In the Matter of)
) Docket 50-344
PORTLAND GENERAL ELECTRIC COMPANY,)
) (Control Building Proceeding)
et al)
)
(Trojan Nuclear Plant))

I hereby certify that on June 29, 1979, Licensee's letter to the Director of Nuclear Reactor Regulation dated June 29, 1979 and an attachment entitled "Request for Additional Information, Trojan Nuclear Plant, Proposed Control Building Design", have been served upon the persons listed below by depositing copies thereof in the United States mail with proper postage affixed for first class mail.

Trojan Nuclear Plant
Docket 50-344
License NPF-1

Enclosed are responses prepared by Bechtel Power Corporation to an additional 14 of the 50 questions submitted in your letter of May 18, 1979. In accordance with our discussion with your staff, we expect to transmit responses to the remaining questions by July 6.

DETAIL AT COLUMN LINES (N) AND (46)
BETWEEN EL 45'-0" AND EL 65'-0"

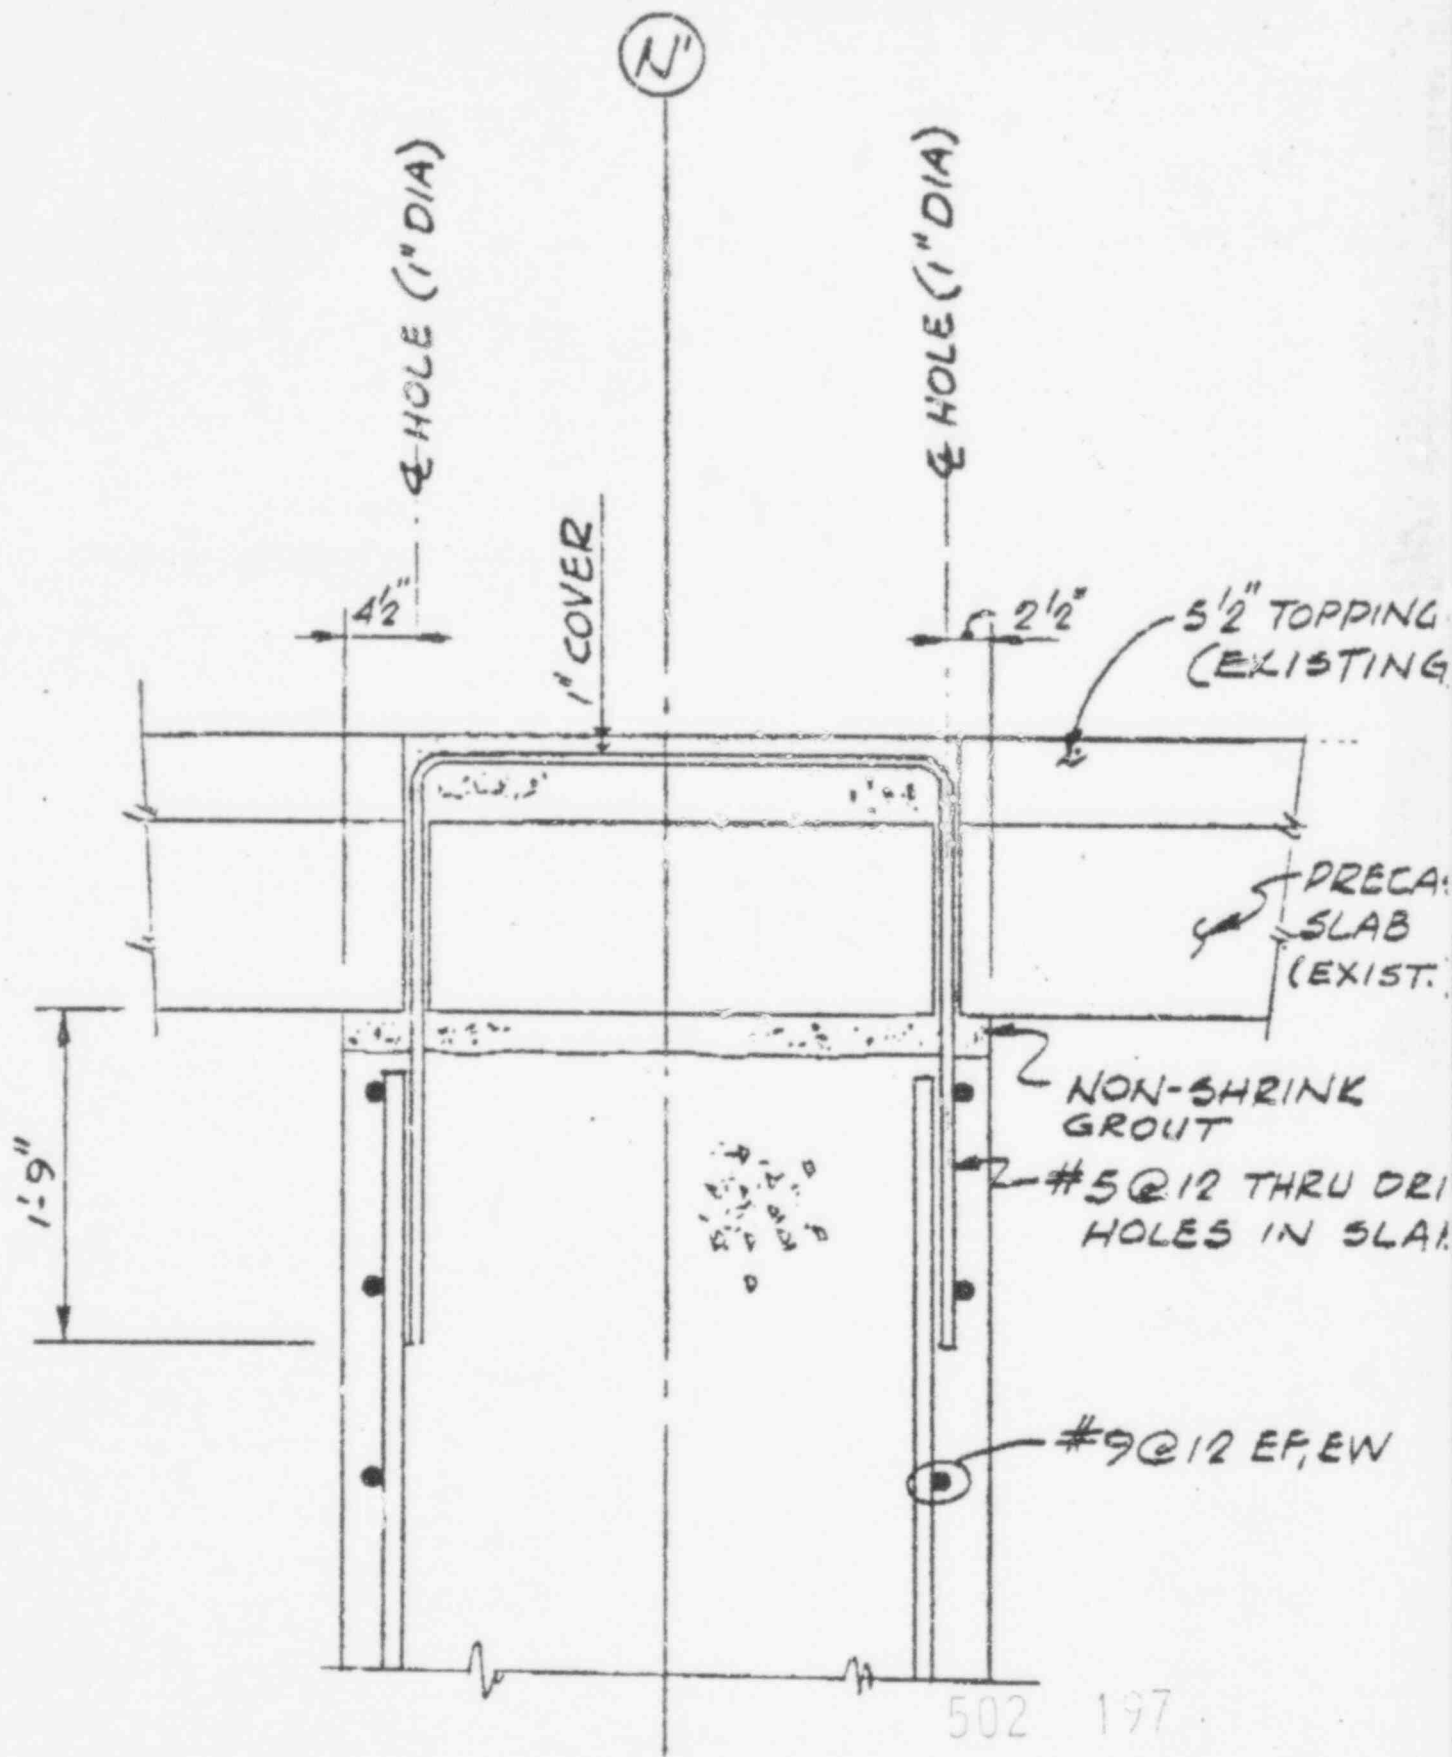
Provide clear, detailed sketches and descriptions of the connection interfaces of the additional walls to the existing structure. Additionally, describe the methods by which the effects of concrete creep and shrinkage (causing tension in the walls and/or a reduction in assumed dead weight) have been factored into the design of these additional walls. Describe and justify in detail the design and the procedures for the connections of the new walls to the existing structure.

Detailed sketches of the connection interfaces between the new walls and the existing structure are attached. The final design may require some minor revisions to the actual sizes and spacings of the rebar and studs. The sketches show representative connection details that will be used. The connection interfaces are discussed below.

Typically, where steel beams occur at a horizontal interface, studs are used to transfer shear forces and vertical rebars are used to transfer tension forces. At horizontal interfaces where steel beams do not exist, vertical rebars make the connection. In some cases friction type A-490 bolts are also used in the connections between the new walls and the existing concrete.

The typical treatment for vertical interfaces is to expose the columns and weld studs to them. New rebars are spliced with the exposed horizontal existing rebars by cadwelding. Drilled and grouted horizontal rebars are also used to make the connections.

PARTIAL PLAN SHOWING
AIR SUPPLY PATH TO DIESEL GENERATOR ROOM

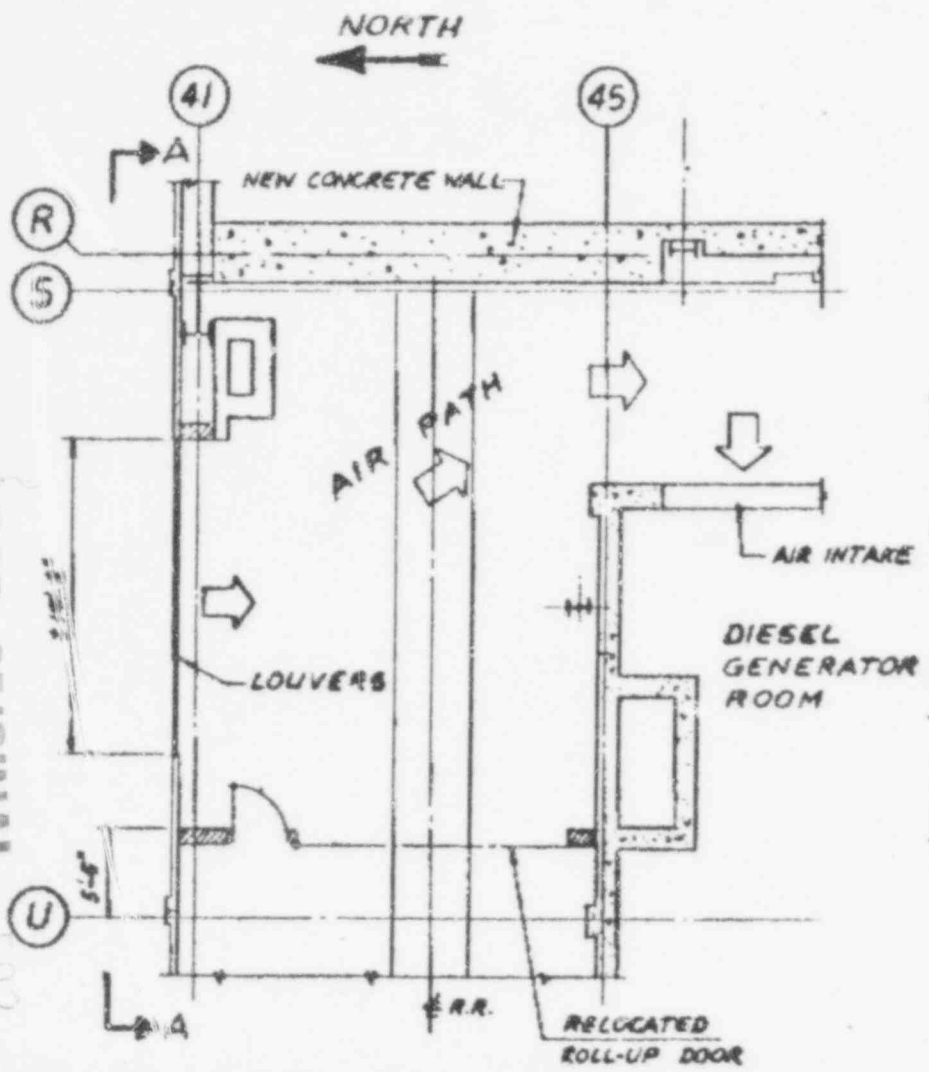
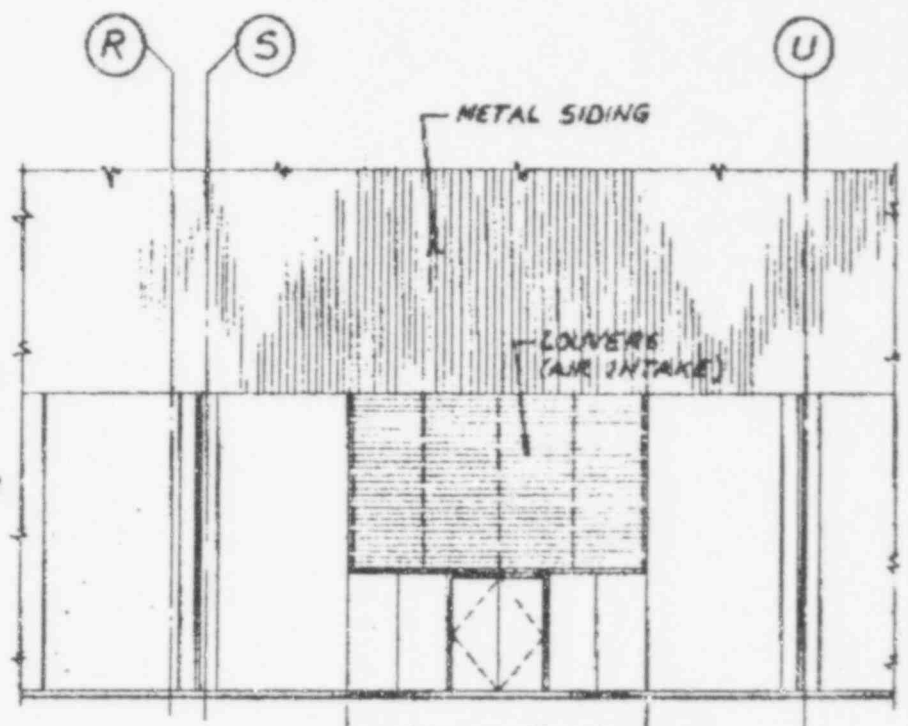
Summarize the loads and load combinations and corresponding acceptance criteria for which the diesel generator air intake will be designed. Include a discussion of how the effects of the Turbine Building, a non-Category I structure has been considered.

The new diesel generator air intake through the north wall of the Turbine Building consists of a louvered opening in the wall. The purpose of the louver is to keep wind, rain, and debris from entering the Turbine Building. The louvers need not be designed for abnormal loads since their collapse would not preclude air supply to the air intake located on the East side of the Diesel Generator Room. In any event, the air intake on the north wall of the Turbine Building has been sized to allow blockage of 50% of the area. The attached figure shows the location of the louver and the air supply path to the Diesel Generator Room.

The fact that the Turbine Building is not a Category I structure has no effect on supplying air to the Diesel Generator Room because it has been designed to resist a Safe Shutdown Earthquake (FSAR Sec. 3.8.1.1.6). The siding and the connections have been analyzed and it has been determined that the siding will not become detached during a Safe Shutdown Earthquake.

FIGURE 41-1 ULTIMATE STRENGTH OF SHEAR WALL SPECIMENS

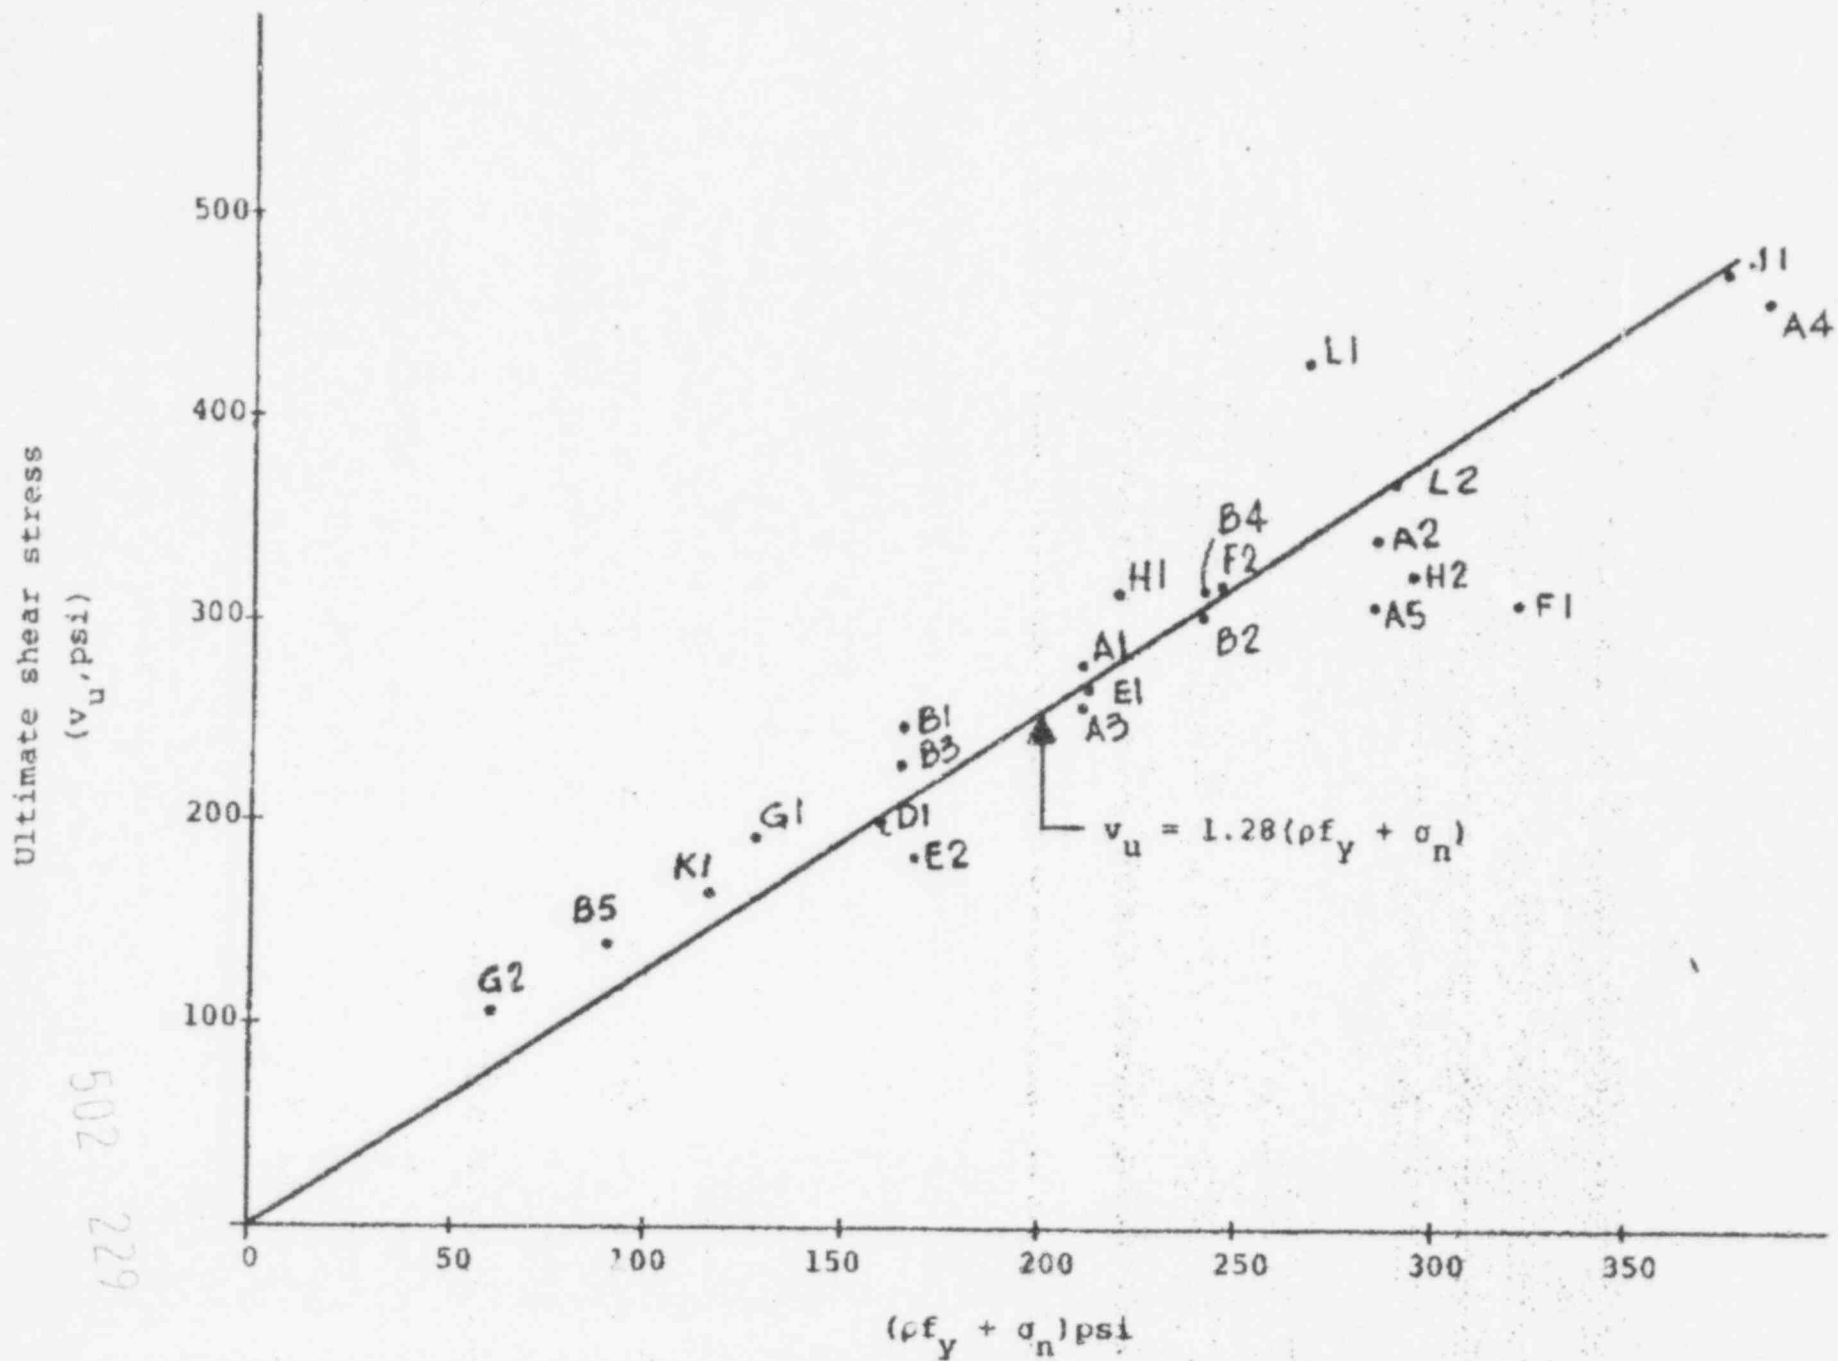
Discuss in detail the error band associated with each of the test results (e.g., stiffnesses, strengths, degradation, etc.). Explain and justify how these were factored into your evaluation of the complex.

The accuracy and consistency in the test results are demonstrated in Figure 41-1 by the small scatter among the ultimate strength of all the 23 specimens. This type of experimental scatter is common among the results of concrete test specimens. Such a scatter can be attributed to various sources as discussed above and other probable sources such as the construction joint at the beam-specimen interface. The consideration of error band associated with the test results is not applicable to the capacity evaluation because the test results were not used directly, as explained in Section 3.4 of PGE-1020.

Figure 49-1 Representative Floor Response Spectra : 0.15g OBE

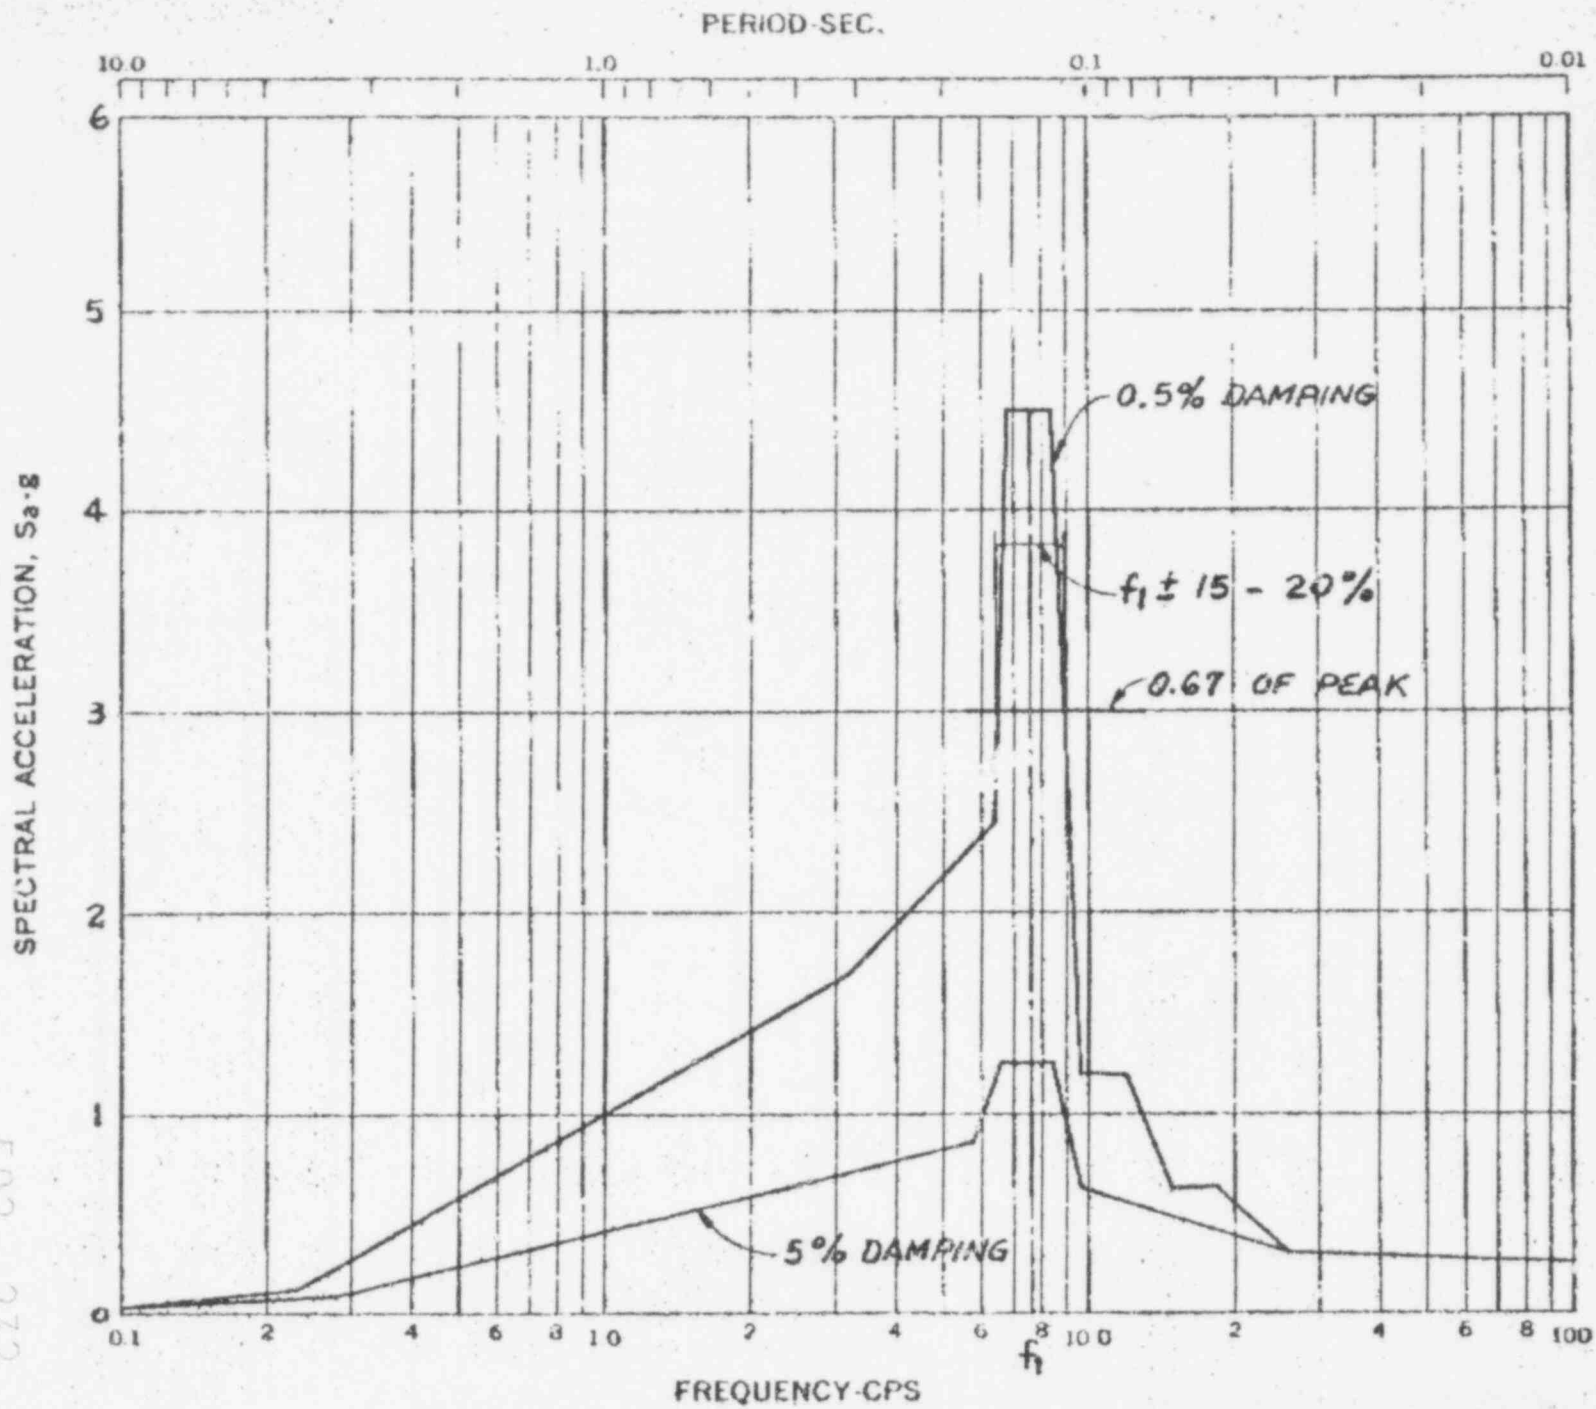
Compare the slopes of the sides of the peaks in floor response spectra for the complex frequency shift vs. stress (therefore, ground acceleration) level as derived from the test data results to verify that the floor response spectra are conservative for all earthquake levels for both the OBE and the SSE spectra. Justify any non-conservative deviations.

In considering the adequacy of the OBE response spectra, a review of stiffness reduction factors was made to determine the largest earthquake that could occur before significant reduction in frequency resulted. It was estimated that for an earthquake of approximately 0.10g the stiffness reduction would be approximately 2% resulting in a 1% shift in frequency. The response spectra associated with the 0.10g earthquake was estimated by assuming the same general shape as for the 0.15g OBE except the frequencies associated with the peaks are increased and the ordinates are reduced by the ratio of $0.10/0.15 = 0.67$. The estimate of the increase in frequency was made by considering several of the STARDYNE analyses involved in the overall stiffness iteration process. This resulted in an increase of 5 to 7 percent. This is the shift of the first mode in the N-S direction, and the shift associated with the other modes is less. Since the peaks of the response spectra have sloping sides, the width

of the peaks increases with decreasing acceleration. As shown in Figure 49-1, the width of the peaks of the response spectra for an 0.15g OBE varies between 15 and 20 percent at 0.67 of the peak ordinate. This will allow the frequency shift of 5 to 7 percent, plus approximately 10 percent curve broadening, with the resulting spectra for an 0.10g earthquake still being within the 0.15g OBE response spectra. As the earthquake level increases from 0.10g to 0.15g, the stiffness reduction factors decrease gradually which will result in a gradual transition to the 0.15g response spectra.
